**REVIEW OF THE
REVISED HUNTINGTON PILOT PLANT SITE PROFILE**

**Contract No. 200-2009-28555
SCA-TR-SP2013-0043**

Stephen F. Marschke

June 2013

Figure 1: Uranium Gamma Spectrum, using MicroShield

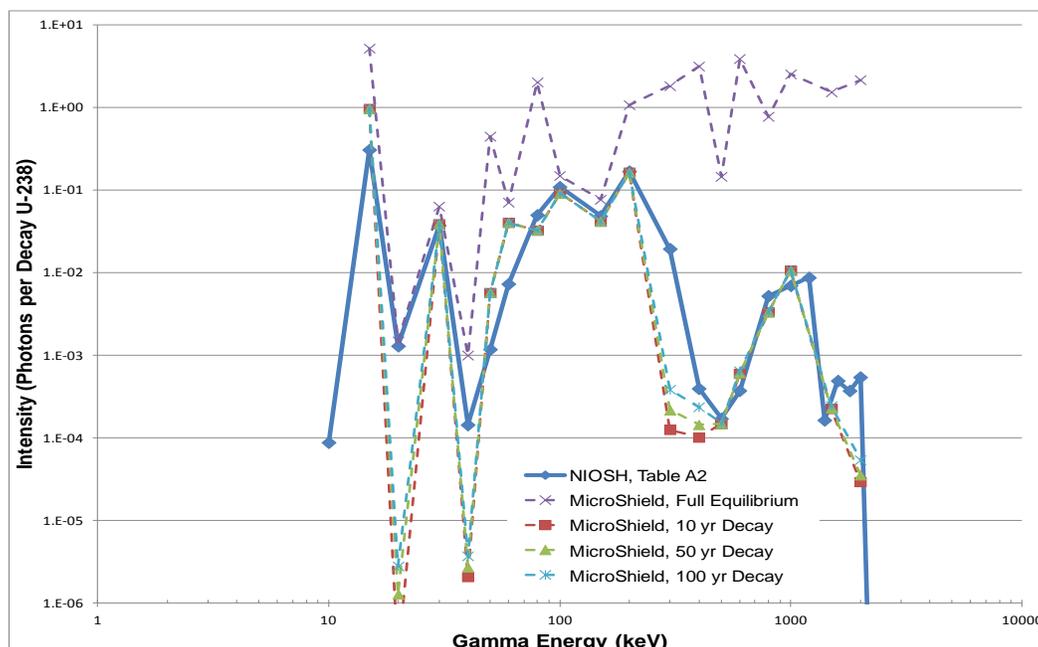
As Figure 1 shows, when full equilibrium is assumed, there is considerable disagreement between the MicroShield and Table A2 gamma spectra. SC&A next used MicroShield to create gamma spectra at decay times of 10, 50, and 100 years. These would be the conditions before Th-230 and its progeny could grow in for the U-238 series and before any Pa-231 and its progeny could grow in the U-235 series. These would be the conditions one would expect from the types of uranium handled at HPP (not including any recycled uranium). The same procedure was followed to develop the gamma spectra, and the results are shown in Figure 1 as the red, green, and light blue dashed lines. Figure 1 now shows that there is much better agreement between the Table A2 and MicroShield gamma spectra. Although there are differences between the Table A2 and MicroShield gamma spectra, those differences are not considered significant. The differences are likely due to different decay times, different energy binning, etc.

Figure 2: Uranium Gamma Spectrum, using the National Nuclear Data Center

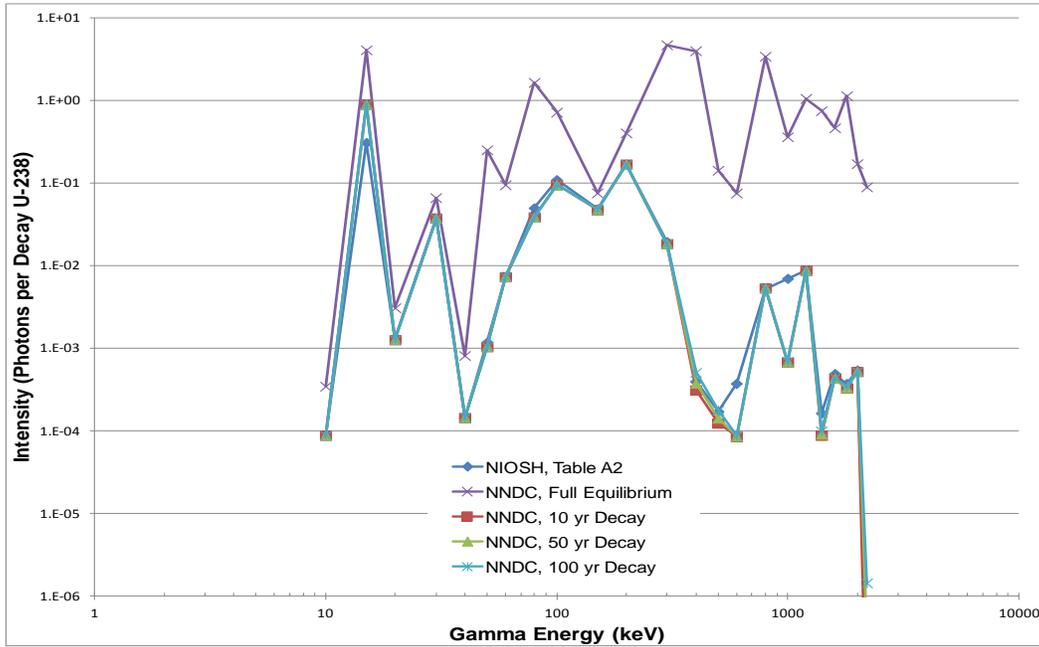
With the possible exception of 600 and 1,000 keV, Figure 2 shows that SC&A was able to almost exactly match the Table A2 gamma spectrum with data from the NNDC. As with the MicroShield comparison, the Figure 2 agreement between the SC&A and Table A2 gamma spectrums is considered good. The differences are likely due to different assumed decay times, different energy binning, etc.

Observation 1: Consistent with HPP operations, the gamma energy spectrum used by NIOSH is not based on full equilibrium of U-238, U-235, and U-234 with their decay products; rather it is consistent with a decay period where only short-lived progeny of U-238 and U-235 would have had an opportunity to grow in.

Figure 3: Uranium Beta Spectrum, using the National Nuclear Data Center

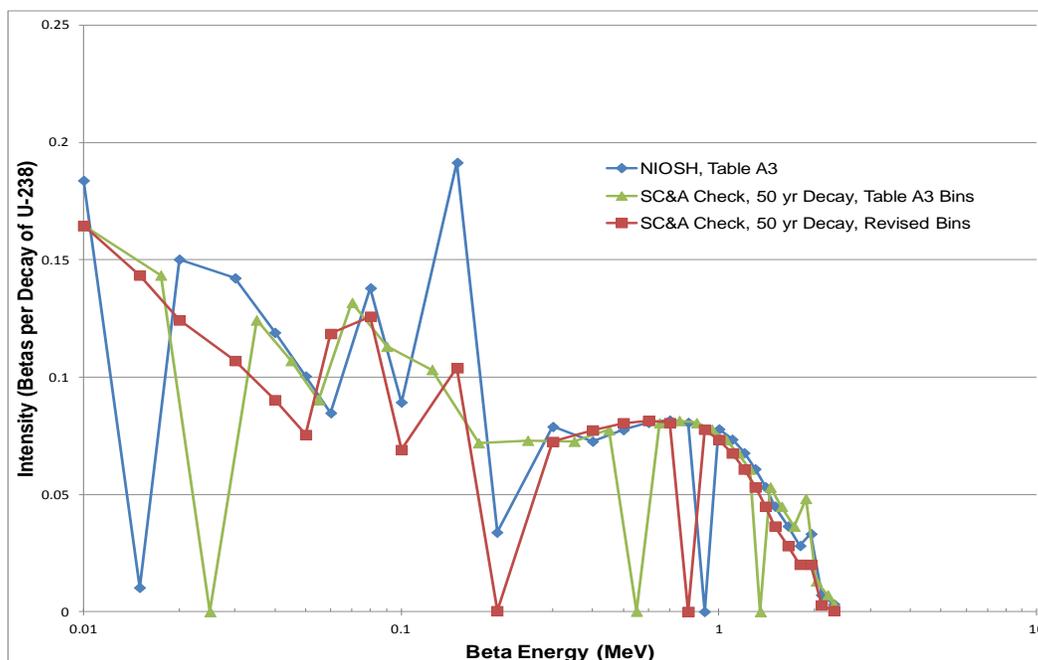
The SC&A-developed beta spectra are shown in Figure 3 (green line). Similar to the gamma spectra, there are significant differences between the SC&A-developed beta spectra and the Table A3 spectra (shown as the blue line in Figure 3).

Regardless of the manner in which the beta energy bins are defined, the agreement between the two SC&A-calculated beta energy spectra and the Table A3 energy spectra is considered good.

Observation 2: Consistent with HPP operations, the beta energy spectrum used by NIOSH is not based on full equilibrium of U-238, U-235, and U-234 with their decay products; rather, it is consistent with a decay period where only short-lived progeny of U-238 and U-235 would have had an opportunity to grow in.

Figure 4: MicroShield Dose Rate from a 20-Gallon Drum by Gamma Energy

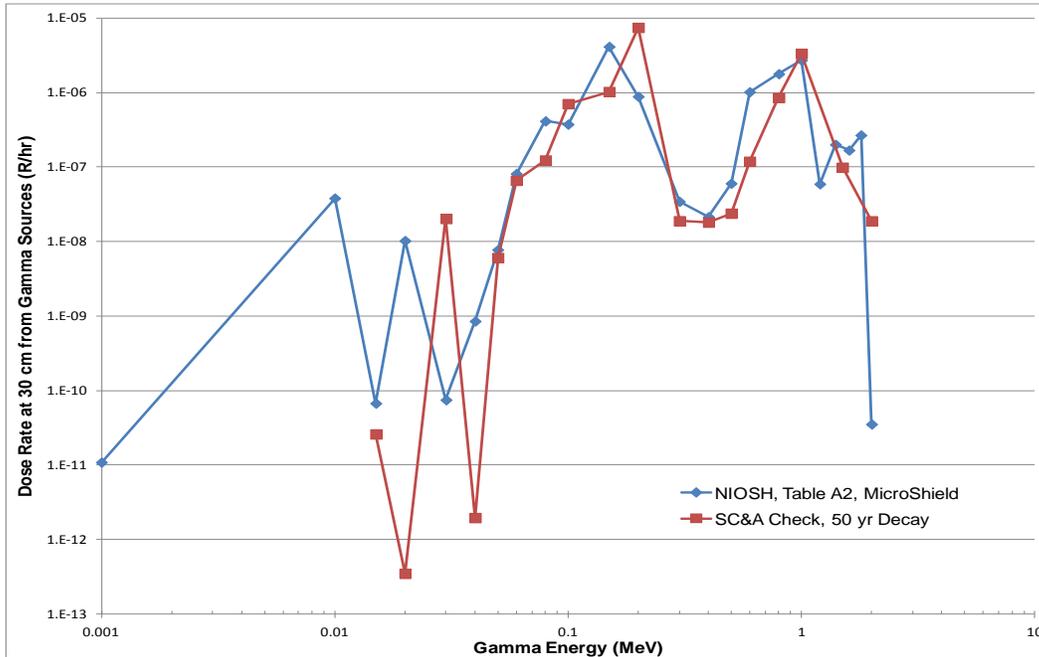
Figure 4 shows the dose rate as a function of the gamma energy spectrum, while Figure 5 shows the cumulative dose rate as a function of the spectrum. As expected based on the above discussion, there is good agreement between the calculated dose rates.

Figure 5: MicroShield Dose Rate from a 20-Gallon Drum – Cumulative over Gamma Energy

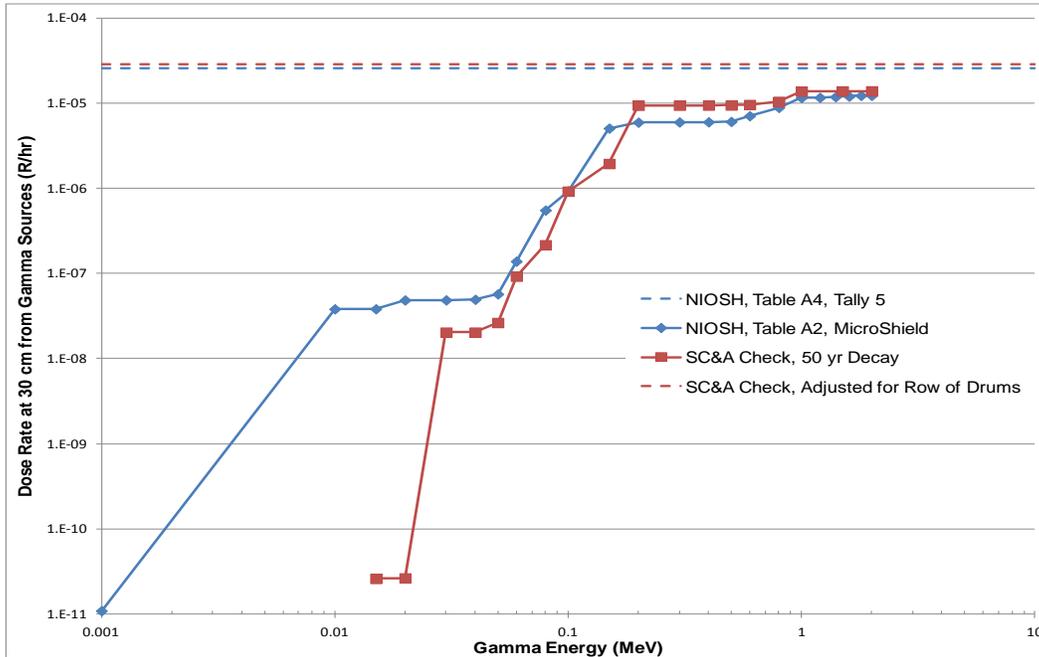
Figure 5 also shows the Table A4 dose rate of 2.56×10^{-5} rad/hr (the dashed blue line). If it is assumed that the difference between the MicroShield dose rate and the Table A4 dose rate is due to a single drum versus an array of drums, and if it is assumed that this same difference will be maintained for the MicroShield-generated gamma spectrum, then the resulting dose rate due to an array of drums is estimated to be 2.9×10^{-5} R/hr (the dashed red line on Figure 5). Considering the differences between MicroShield and MCNPX, the gamma spectrums, one drum versus an array of drums, is considered to be good agreement.

Observation 4: The penetrating dose rate calculated by NIOSH using MCNPX and modeling an array of drums is consistent with the dose rate calculated by SC&A using MicroShield and modeling a single drum. Furthermore, the MicroShield-calculated dose rate using the Table A2 gamma energy spectrum is consistent with the dose rate calculated using the gamma energy spectrum from the MicroShield radionuclide decay library.

Figure 6: Energy Distribution for Photon Emissions
(OCAS-TKBS-004, Figure A1)

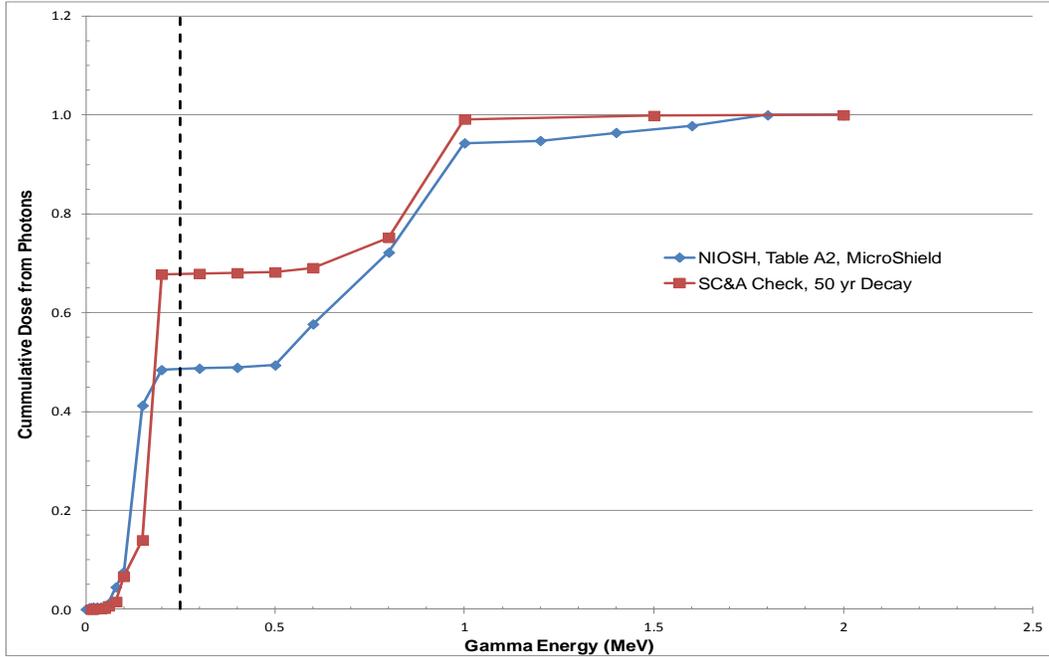
Finally, Figure 6 is an attempt to reproduce OCAS-TKBS-0004, Figure A1. As shown, when the Table A2 Gamma energy spectrum is used, there is good agreement between Figure 6 and Figure A1, and the dose breakdown is approximately a 50/50 split for 0–250 keV/>250keV. However, when the MicroShield spectrum is used, the dose breakdown is ~70% for 0–250 keV and ~30% for >250 keV.

Finding 4: The dose breakdown between 0–250 keV and >250 keV varies from 50/50 to about 70/30, depending on the gamma spectrum.
